RE: Modification Request
WPDES Permit Number WI-0046566-07-0
Carol Investment Corporation
Sunrise Shopping Center (Ace Hardware Store)
1009 Marquette Avenue
South Milwaukee, Wisconsin 53172
BRRTS #: 02-41-576336 & 02-41-579429
FID #: 241828620

In a letter dated July 21, 2022, Wisconsin Department of Natural Resources (WDNR) granted coverage under WPDES Permit Number WI-0046566-07-0 to Carol Investment Corporation for the discharge of treated sump water to the stormwater sewer system adjacent to the Ace Hardware store (1009 Marquette Avenue, South Milwaukee) located at the Sunrise Shopping Center (Site ID 63340). The approval included discharge from a total of three (3) treatment systems to two (2) outfalls (001 and 011). Discharge to Outfall 001 is permitted for water collected in the sump located in the northwest corner of the basement of Ace Hardware (Sump 1) and treated by a system that began operation on May 14, 2019. Discharge to Outfall 011 is permitted for the combination of water collected in the two (2) southern sumps (Sumps 2 and 3) installed in the Ace Hardware basement in 2023 and treated by systems that began operation on September 1, 2023.

PHOTO #4

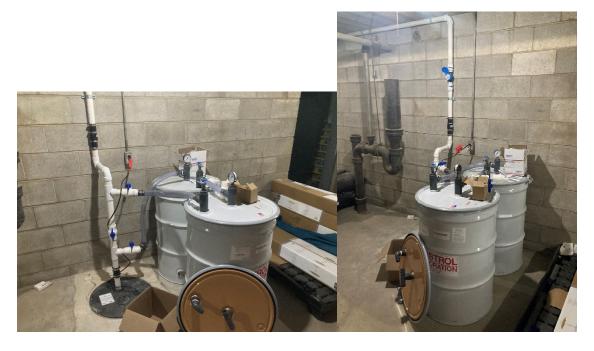
IMAGE OF SUMP 3 AND ASSOCATED REMEDIATION SYSTEM; PVC PIPING CONNECTS TO DISCHARGE LINE THAT RUNS THROUGH SOUTHERN WALL OF ACE HARDWARE BASEMENT (OUTFALL 011)

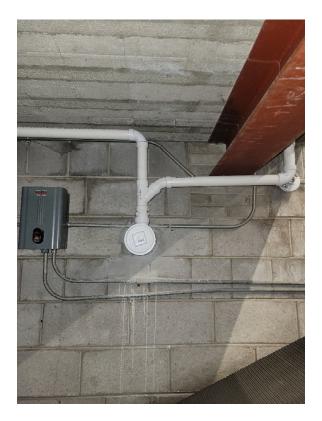
IMAGE OF DISCHARGE LINE THAT RUNS THROUGH SOUTHERN WALL OF ACE HARDWARE BASEMENT (OUTFALL 011); SAMPLE PORT IN BOTTOM OF DISCHARGE LINE NOT PICTURED
